Technical Notice

Product Name: ACE-818APM-RS
ACE-A130B-R10
ACE-A130B-S-R10
ACE-A140A-R11

This notice is to inform you of changes to the ATX connector of the ACE-818APM-RS, ACE-A130B-R10, ACE-A130B-S-R10 and ACE-A140A-11.

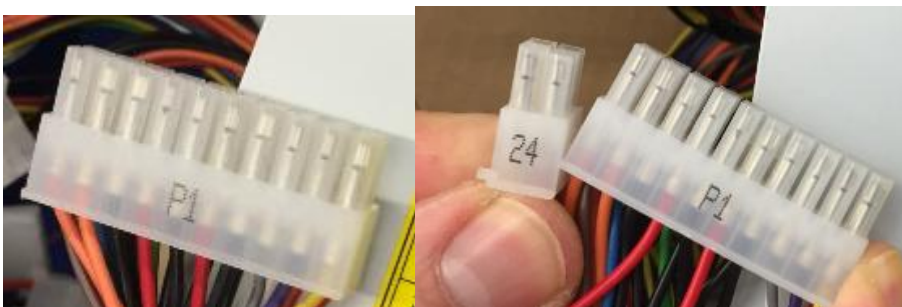
Change ATX connector from 20 pins to 20+4 pins.

This modification has been implemented in production from week 23, 2015. The first three numeric digits of the S/N on the label of the power supply represent the production week and year. The power supplies with a S/N greater than (or equal to) 523 are all equipped with the new ATX connector. For example: S5231050001.
